Project Title:
SEATTLE NATIONAL GUARD ARMORY

Sheet Contents: FLOOR PLAN, REFLECTED CEILING PLAN, SECTIONS, DETAILS

Sheet Contents:
KITCHEN POWER & LIGHTING PLANS

GENERAL NOTE:
SHEETS RK. 1 & RK. 2 FORM PART OF CHANGE ORDER NO. 1 - REVISION TO THE KITCHEN EQUIPMENT DINGS. DATED 5/11/73.

KITCHEN LIGHTING PLAN
SCALE: 1/8" = 1'-0"

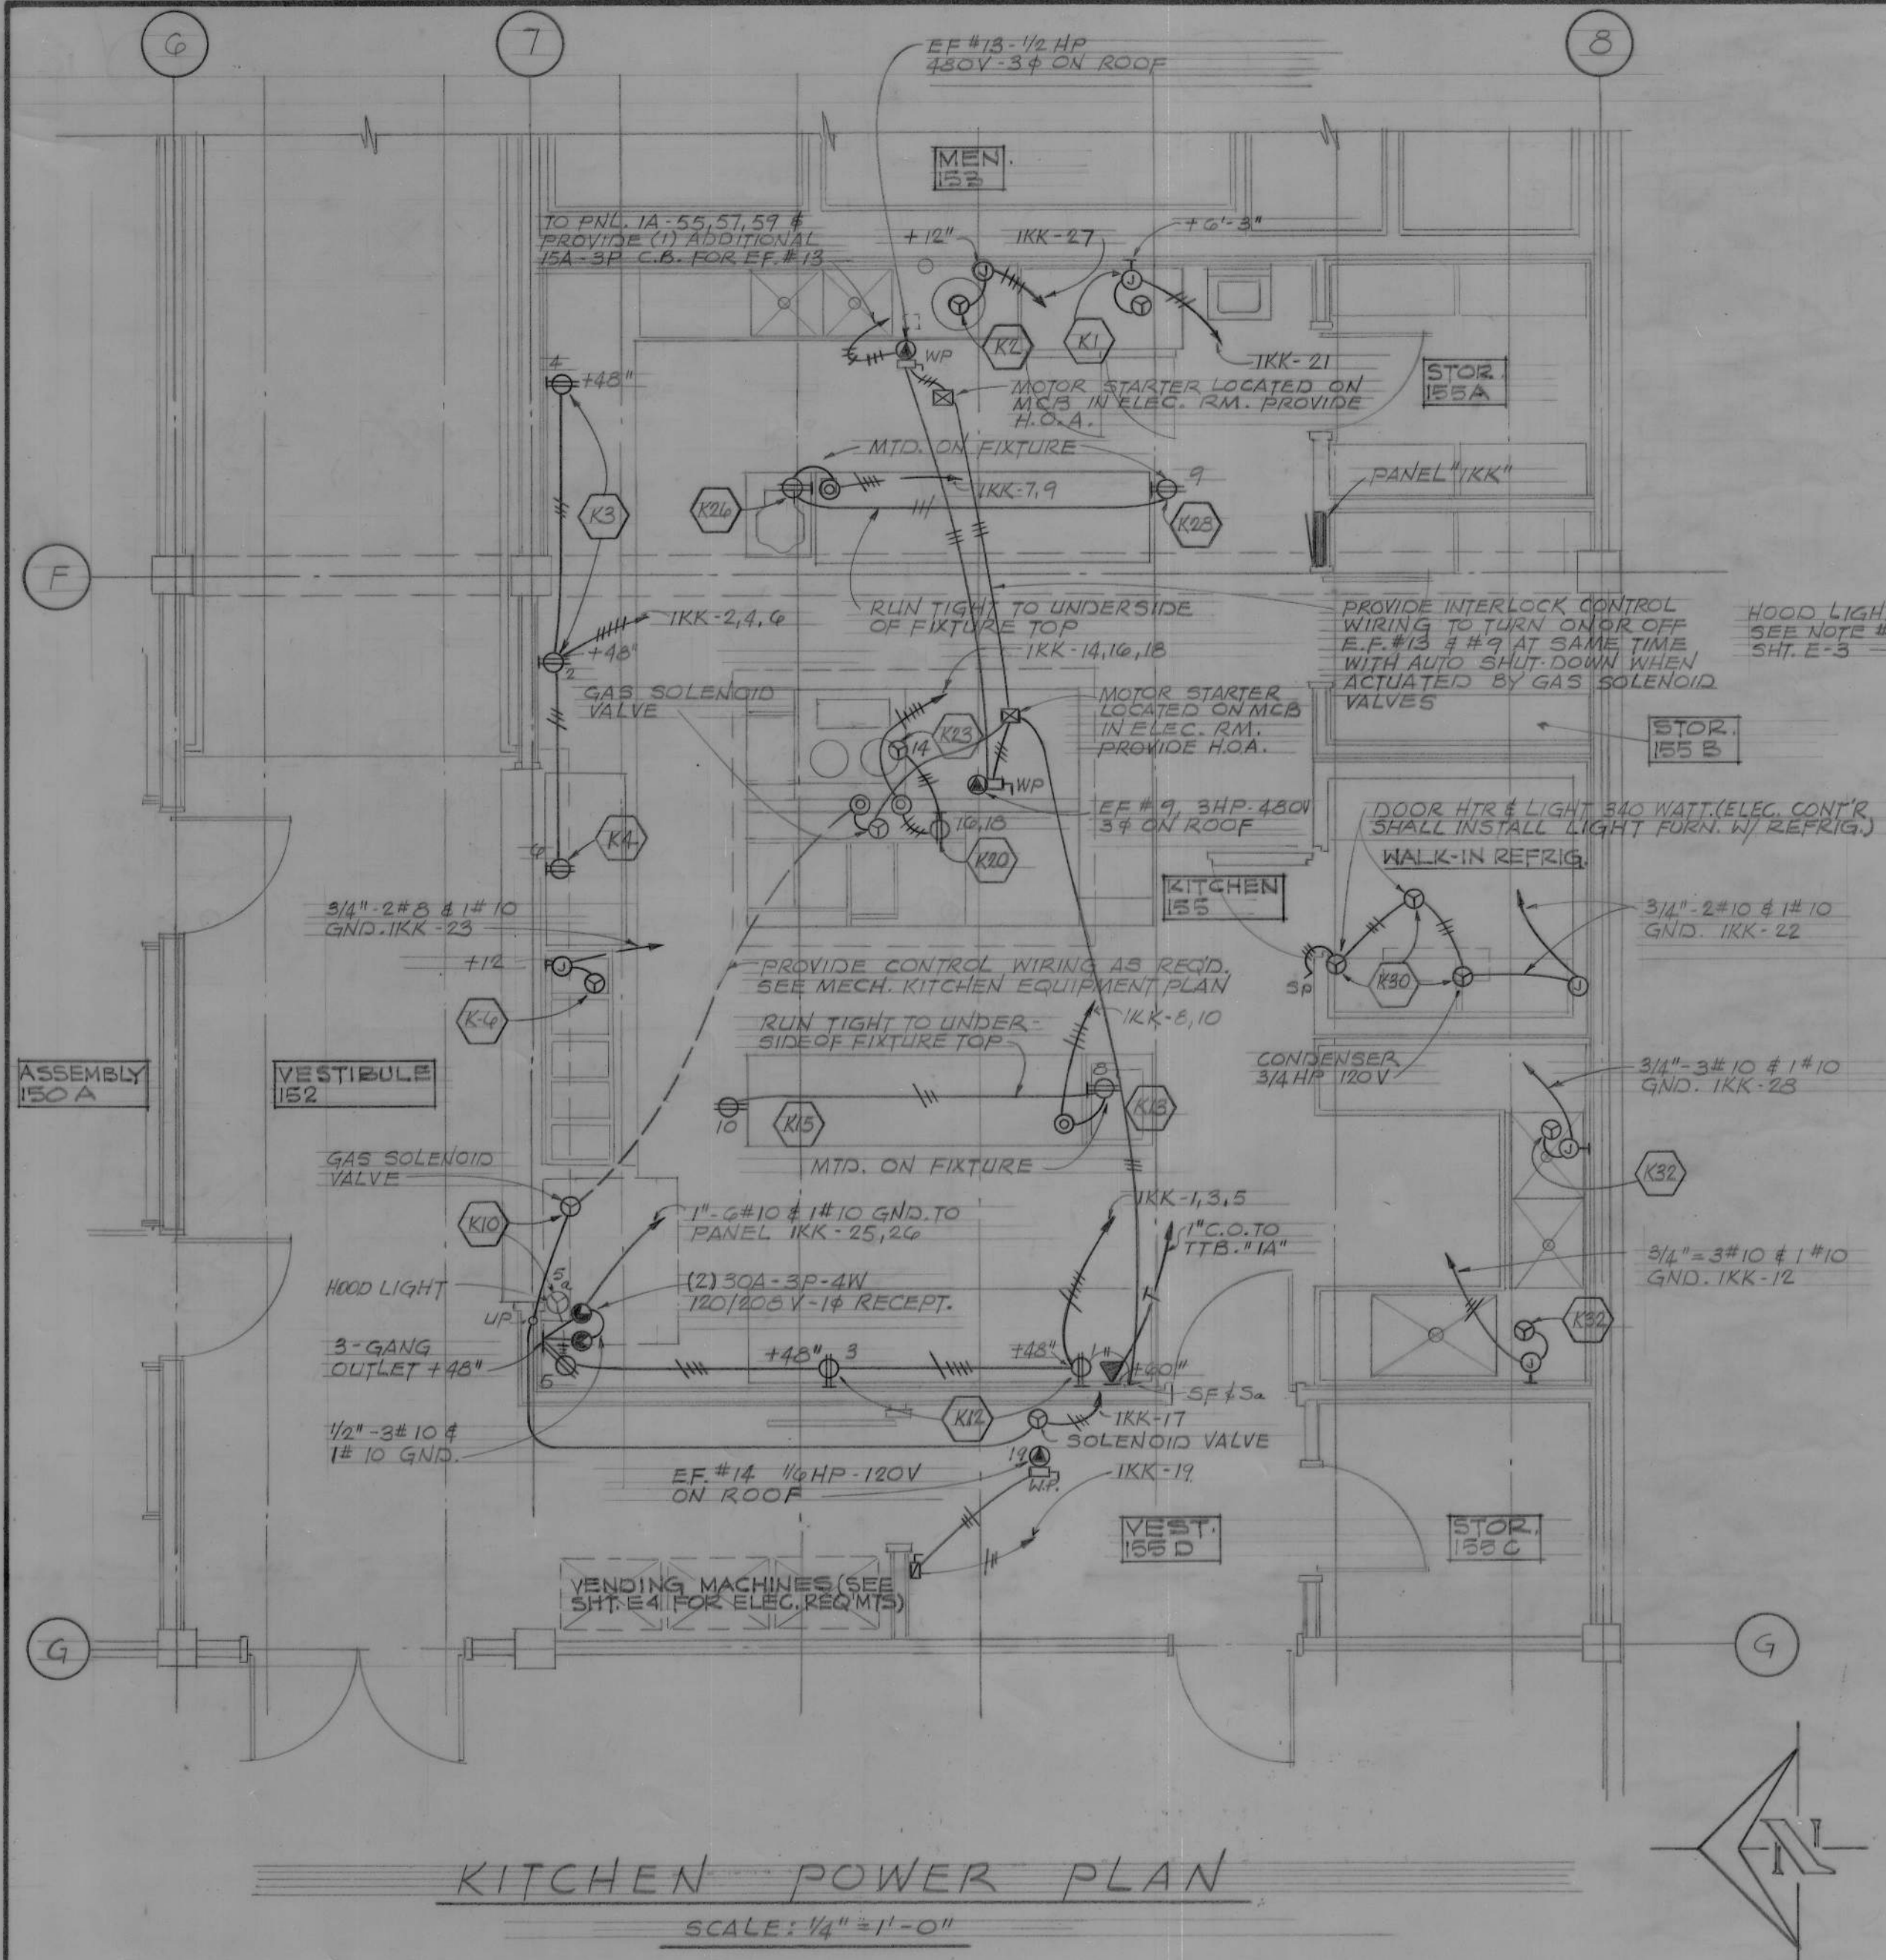
- NOTE:
1. FIRE SPRINKLER SYSTEM FOR KITCHEN HOODS SHALL COMPLY WITH NFPA 13 & 96. PROVIDE REQUIRED TYPE & TEMPERATURE PENDANT HEADS, GAFFLES, ESCUTCHEONS, ETC. THAT ARE EXPOSED TO BE STAINLESS STEEL.
 - 1a. SPRINKLER HEAD TO BE MTD. IN HOOD FOR UNDER HOOD PROTECTION, COORDINATE W/ HOOD SUPPLIER.
 - 1b. SPRINKLER HEAD TO BE MTD. IN HOOD PLENUM ABOVE GREASE FILTERS.
 - 1c. SPRINKLER HEADS TO BE MTD. IN HORIZONTAL DUCTWORK.
 - 1d. SPRINKLER HEAD IN VERTICAL DUCT UNDER FAN.
 2. WHEN FLOW SWITCH IS ACTIVATED BY FLOW OF WATER, THE (2) SOLENOID GAS VALVES SHALL CLOSE & THE KITCHEN HOOD EXHAUST FAN EF-9 SHALL SHUT OFF.
 3. KITCHEN HOOD EXHAUST DUCTS CONCEALED, NO. 14 GAUGE BLACK SHEET STEEL WITH ALL SEAMS & JOINTS WELDED.
 4. THIS IS A REVISED DRAWING OF THE AREA SHOWN. THE SAME AREA ON THE ORIGINAL DRAWINGS SHALL BE DELETED.
